September 10, 2008

Re: FERC Project Nos. 13227 and 13146. Comments on the application for a preliminary permit known as Bull Canyon Pumped Storage Water Power Project and Long Canyon Pumped Storage Water Power Project by Utah Independent Power, the applicants. Pursuant to Federal Register Notice of July 16, 2008, Vol. 73, No. 137.

### Projected Lake Powell and Lake Mead Available Storage by Year Average of 111 traces using ISM simulation

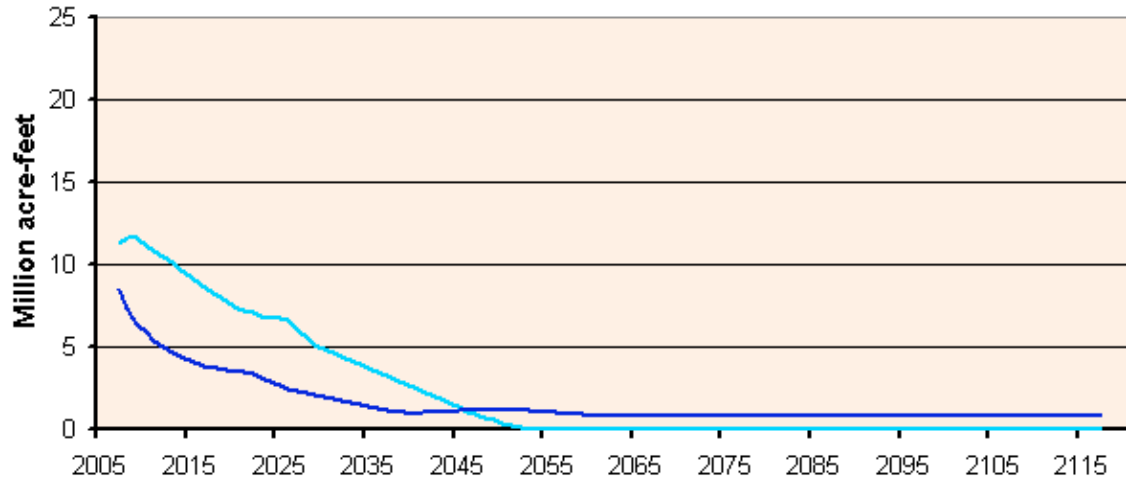
Both federal and university scientists have determined that the Colorado River no longer has surplus water, since the system is over-appropriated and increasing evaporation from atmospheric warming will keep this situation unchanged beyond the duration of a federal 50-year operating permit. This water scarcity problem for the Colorado River basin includes predictions that hydropower production at Glen Canyon and Hoover dams will cease in the near future.

For example, last February the Scripps Institute produced a peer-reviewed paper that concluded Lakes Mead and Powell will empty despite the guidance of Shortage Criteria from the Bureau of Reclamation (2007 FEIS), and provided a timetable: 10% chance by 2013, 50% chance by 2021, and 100% by 2036. The report is based on an annual reduction of Colorado River flows at 10% for the present and 30% by 2060, which is displayed as a graphic below by using Index Sequential Modeling (ISM) according to the open source simulator CROSS found at [www.onthecolorado.org/Cross.cfm](http://www.onthecolorado.org/Cross.cfm) .

The ISM results for projected average hydropower production at Glen Canyon and Hoover dams, is displayed below.

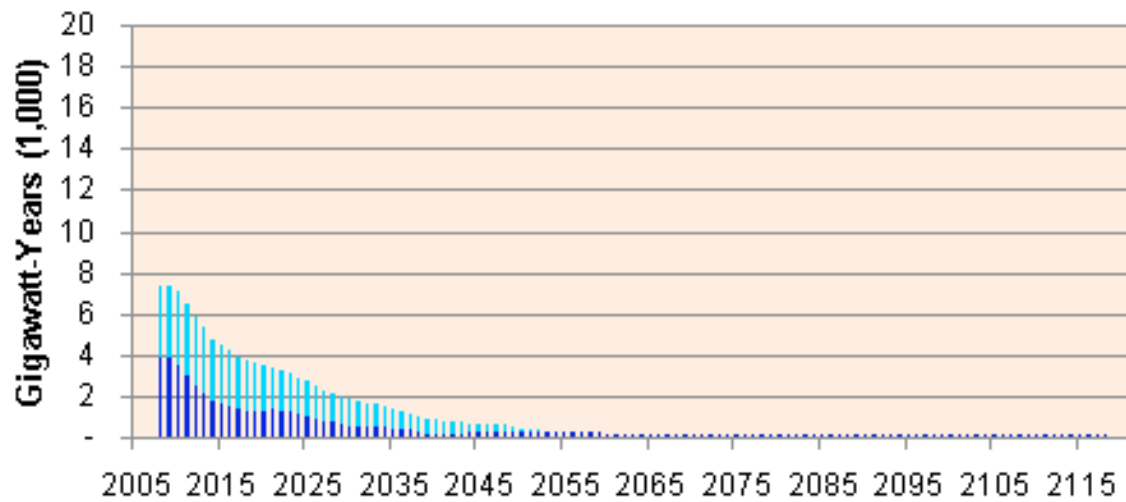
It is not internally consistent to grant a federal license to a hydroelectric facility that needs Colorado River water to operate, when existing Colorado River hydropower facilities are currently stressed from low reservoir levels and predicted to fail entirely within the next 50 years.
